Planning Commission Staff Report

February 9, 2011
Item 6.c.

SUBJECT: PV-203

PURPOSE: Application for a Variance from the Pleasanton Municipal Code to allow a garage to be set back 11 feet, 6 inches from the street-side sideyard property line where a 20-foot setback is required.

Figure 3: Garages

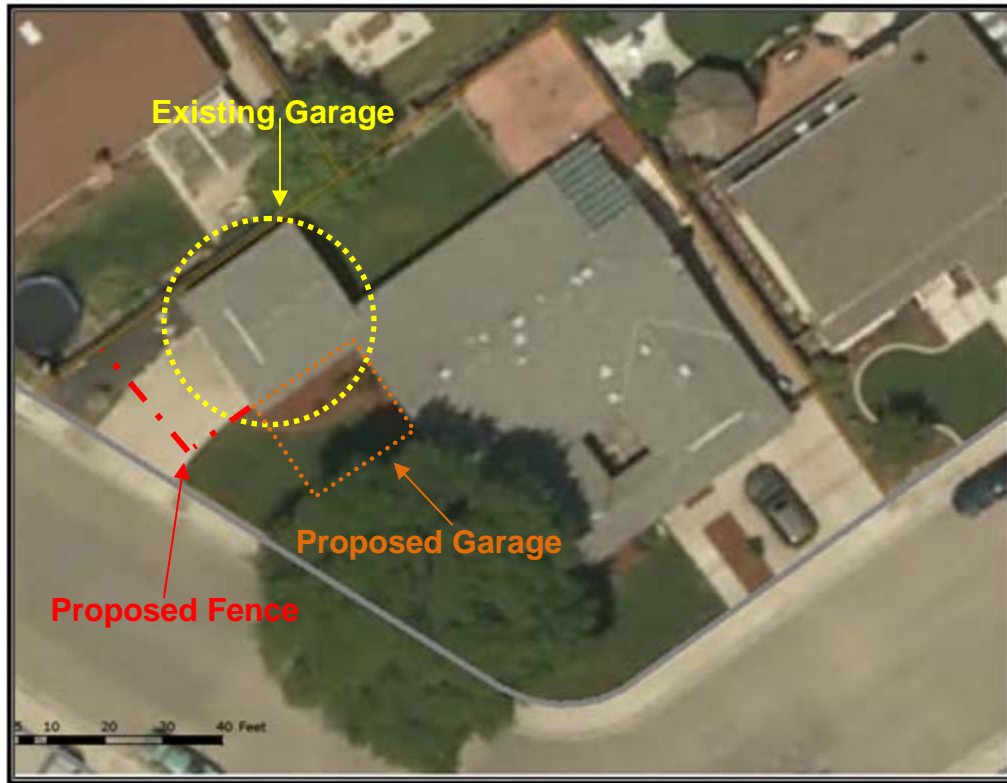
(please see Figure 3 below) along the west elevation. The new garage would be located approximately 19-feet south of the existing garage's location to allow for direct interior access into the house and would be continuous with the rear house wall (please refer to Exhibit B). The applicant is also proposing to construct a new fence along the street-side yard to allow for more usable rear yard space. Fences located on the street-side yard are required to have a minimum 5-foot setback and, as proposed, the fence measures 4-feet 6-inches. Reducing the street-side yard setback for the fence was not included in this Variance request. However, staff would not support a request to reduce the street-side yard setback for the fence and, therefore, the fence would have to be setback an additional 6-inches in order to meet the minimum 5-foot street-side yard setback.

The new garage would replace the existing garage and would be located approximately 19-feet south of the existing garage's location (please refer to Figure 3 on page 4). Although the existing garage is setback approximately 18-feet, the western property line is not at a 90-degree angle and skews to the east (right) towards the interior of the lot. The property line "skew" and location of the existing residence reduces the street-side yard setback as the garage moves closer to the front of the residence. By removing and constructing a new garage, the property owner will gain more usable rear yard space (please see Exhibit B). As proposed, the garage would have a street-side yard setback of 11-feet, 6-inches instead of the 20-feet that is required. The garage would, however, meet the size requirements for parking (20'x10' for each space) in the R-1 zoning district.

Staff analysis: The purpose of the 20-foot setback for a garage is to provide sufficient room for cars to park outside of the garage. Due to the angle of the street-side yard property line, the proposed driveway apron is approximately 13-feet to 19-feet, 6 inches in length. The proposal could create safety impacts if pedestrians and others on the sidewalk have to go into the street because a car is blocking the sidewalk. Therefore, staff believes that the proposal could be detrimental to the public health and safety, thus, this finding cannot be made.

Figure 4: Alternative Layout

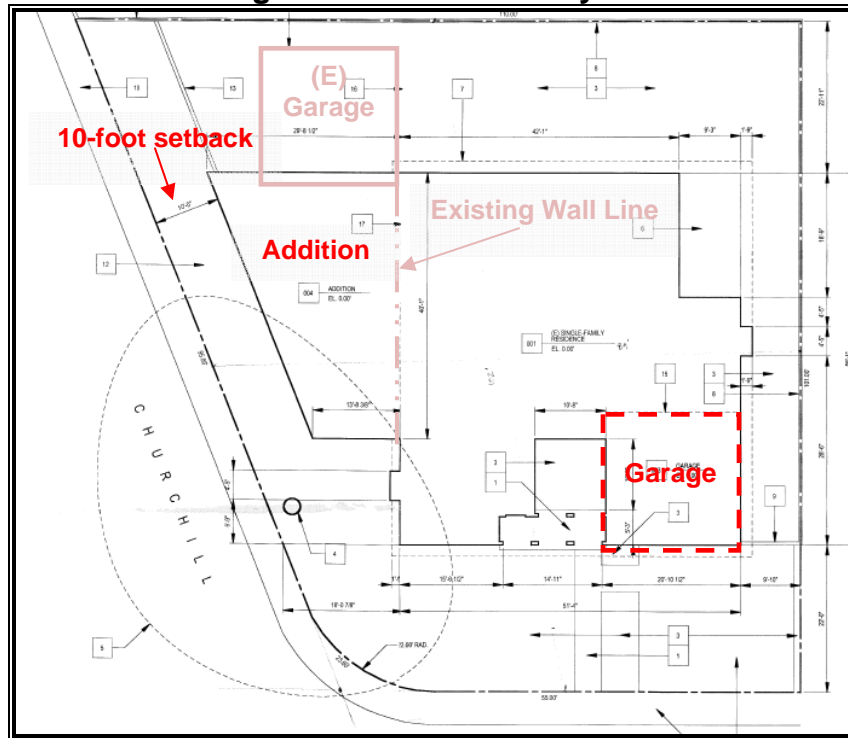
When requesting informal feedback from staff in September of 2010, the applicant had provided staff with two proposals. As shown in Figure 4 (see next page), an alternative would be to construct an addition along the west elevation and return the garage to the front (south) of the house. The addition, unlike garage requirements, would only require a minimum 10-foot setback on the street-side.

The alternative option shown in Figure 4 would meet the setback requirements for the R-1-6,500 zoning district and would not require a Variance. However, without knowing the square-footage or height of the addition, staff does not know if the alternative plan would meet the other development standards (i.e., floor area ratio and height requirements) of the R-1-6,500 district.

The applicant acknowledges the feasibility of alternative solutions (i.e., parallel entry garage or moving the garage to its original location) that would not require a variance; however, he feels that it is unreasonable. The applicant feels that a parallel entry garage, while feasible, would create a large concrete driveway. There are, however, alternative materials that are environmentally friendly and soften the appearance of a driveway (e.g., turf block stone or concrete pavers, gravel, brick, etc.). By returning the garage to the front of the house, the homeowner would gain rear yard space and adhere to the street-side yard setbacks (as shown in Figure 4 above).
